3 April 2006

Shoalhaven City Council
Eric Hollinger (Strategic Project Planner)
PO Box 42
Nowra, NSW 2541

**RE: REVIEW OF BEST PRACTICE METHODS OF ON-SITE SEWAGE DISPOSAL – JERBERRA ESTATE
REZONING INVESTIGATIONS (DRAFT LEP LP155)**

ATTACHMENT A – JERBERRA ESTATE SLOPE MAP

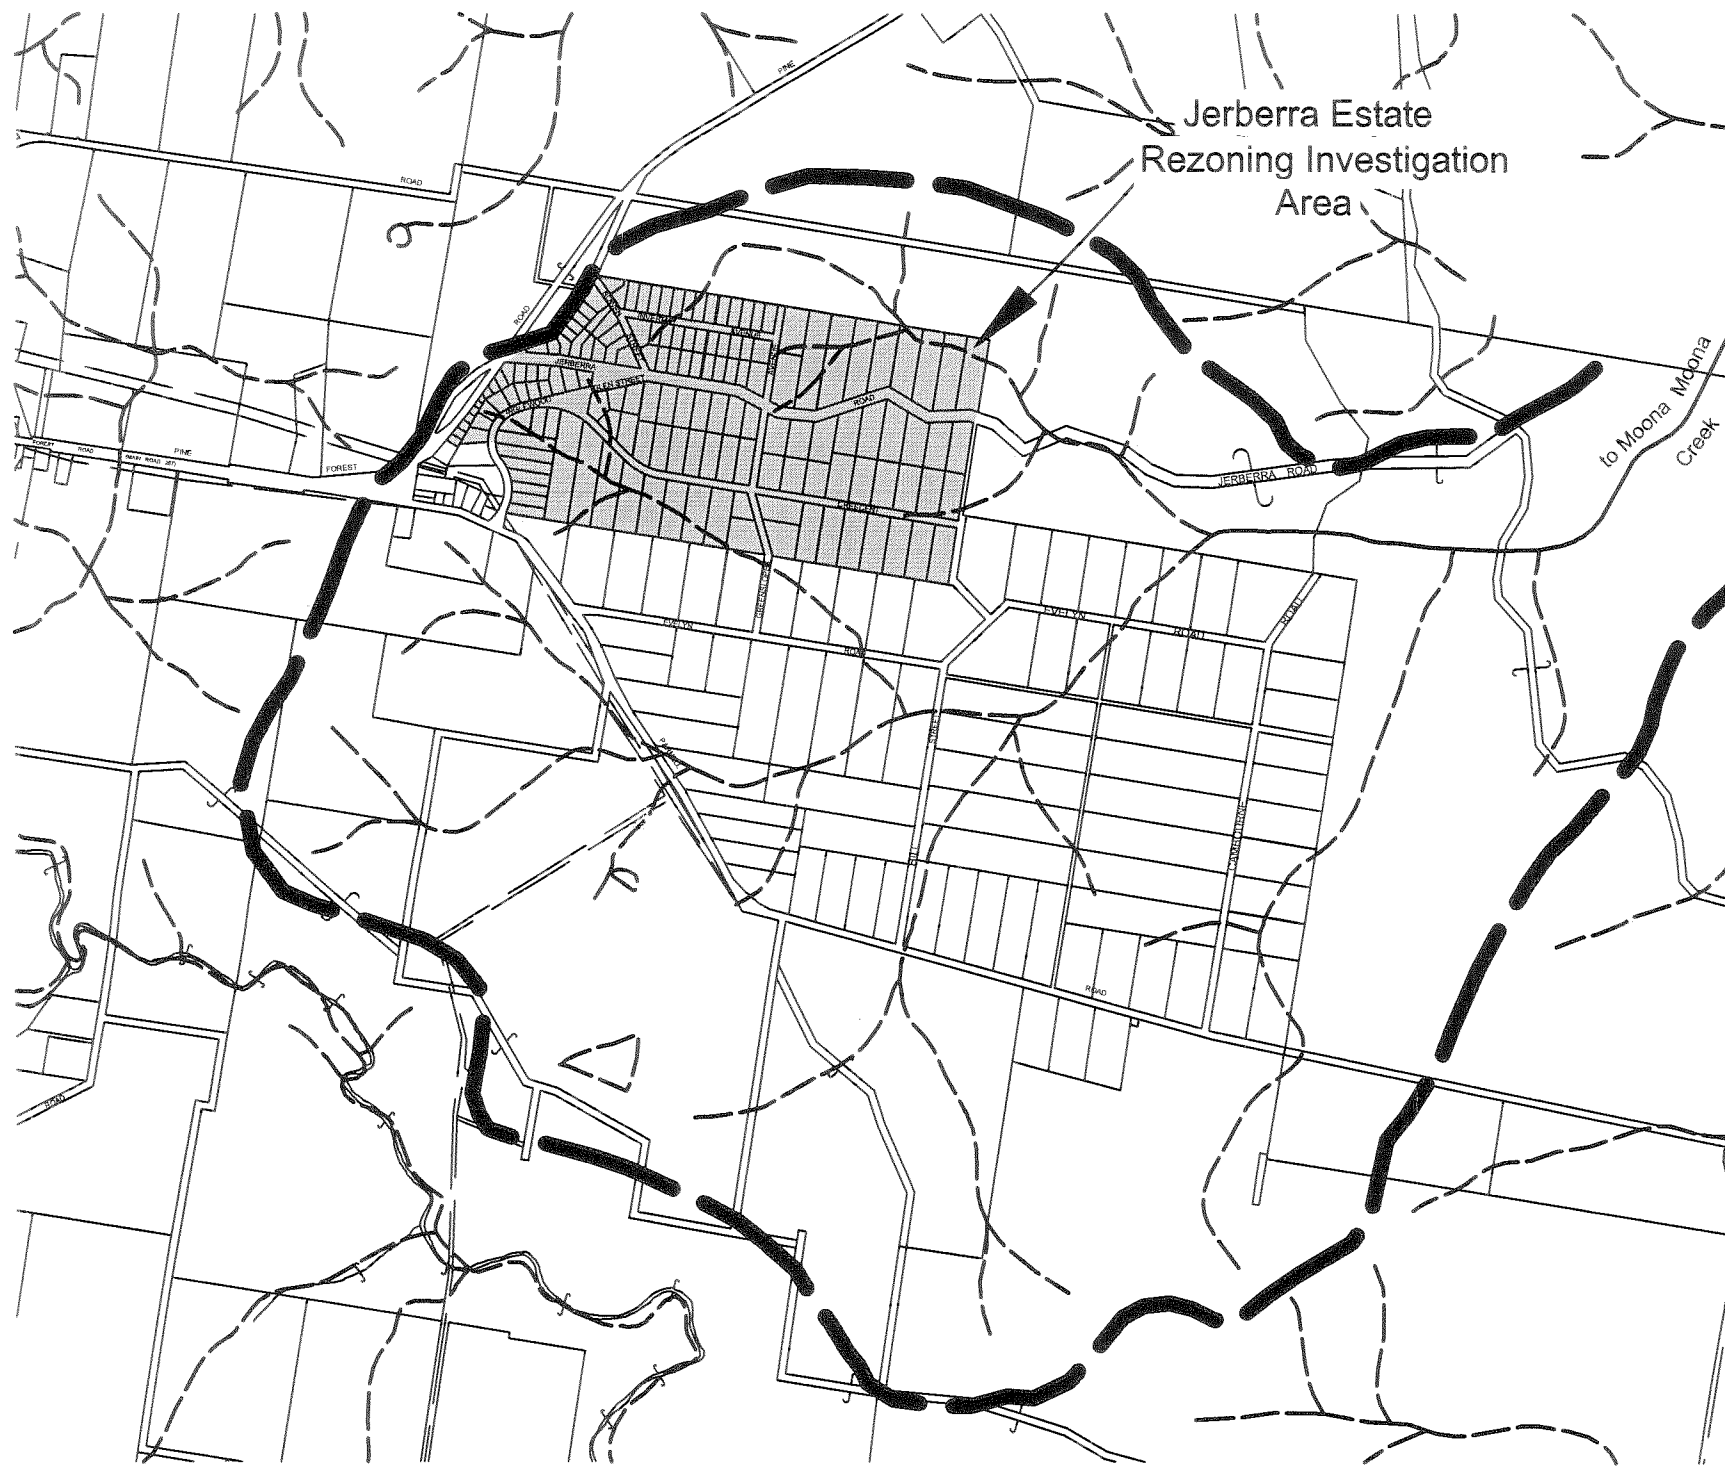
5. In the event that a CES is regarded as one which can be pursued, then a dual reticulation system should be constructed such that reclaimed water can be returned to each allotment. A suitable location for the STP and wet-weather storage facility will need to be chosen. Our preliminary view is that this should be in the NE corner of the site, with a pump-station located in the centre-south of the site (to transfer sewage to the STP at the NE of the site). See Attachment A for preliminary location of these structures. Our preliminary view is that some 150 m² will need to be provided at each allotment as a designated effluent disposal area within the site's landscaping / gardens. This is made on the assumption that nutrient removal (say N = 10 mg/L and P = 2 mg/L), disinfection and tertiary filtration are provided at the communal STP and would need to be confirmed with more detailed analyses.
